The Planning Department,  
County Hall,  
Carrigrohane Road,  
Cork

**Re: Response to Further Information: Planning Ref No: 23/06277 - Permission for the following Large-Scale Residential Development (LRD) comprising of the construction of 272 no. residential units, 3 ESB Substations, 1 no. creche and community use building and all associated site development works including footpaths, car and bicycle parking, drainage, bicycle and bin stores, lighting and landscaping amenity areas. Site development works include road widening works along the eastern side of the L7630 and the provision of a new foot path along the eastern side of the L7630 Broomfield Road together with a new pedestrian crossing. Access to the site will be via 4 new vehicle access points from the existing L7630 Broomfield Road and a new pedestrian connection to Blossom Hill at Broomfield West, Midleton, Co. Cork.**

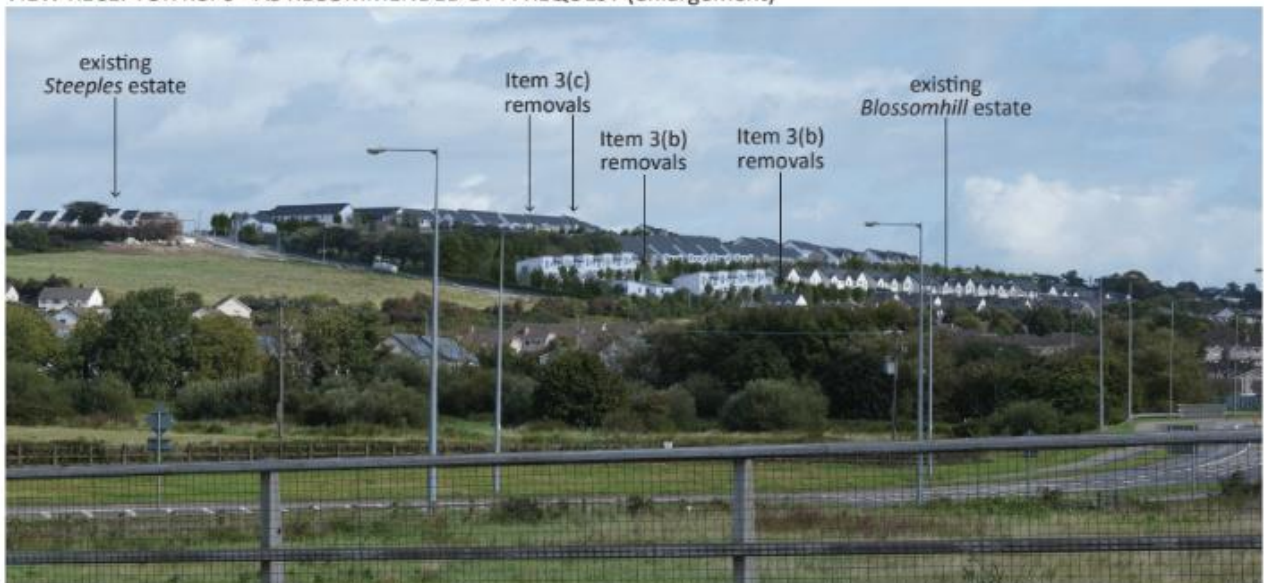
- (b) To protect the residential amenities and privacy of extant dwellings, 8 no. duplex units in the South West Section of the site should be omitted, namely units 9-12, 21-24 on the lower row and units no. 35 – 38 and 49-52 on the upper row. The area/footprint vacated by these units should be duly landscaped to help provide and additional visual and screening buffer to existing residents of the Blossom Hill and Hollyridge development. In addition, the hammerhead turnings areas shall be removed from this area. It is advised that revised drawings reflected this request be submitted.**

In order to accurately assess the impact of the requested omission of the 16 no. units identified, 3 no. investigative photomontages were produced by GNet3D. These included Views 2, 5 and 6 as representative sensitive viewpoints of the original scheme layout. An analysis of this request has been undertaken by Forestbird Design and presents extracts of the LVIA images, showing both the scheme as designed at application stage and with proposed omission of the 18 no. units identified by Cork County Council in their further information request. Please refer to Drawing No. LVA7 by Forestbird Design for further details.

As noted within the LVIA analysis of the request for further information, the omission of the duplex units would result in no visible change to these Views. However, an increased woodland buffer between the duplexes and Blossomhill would be welcomed to improve the visual separation between the two sites. As such, a woodland buffer has been provided within this section of the site.

Within View Receptor 6, the omission of the upper duplex units results in a visual replacement by background houses, so the change is negligible. The recommended removals within the scheme and the omissions results in no change to LVIA.
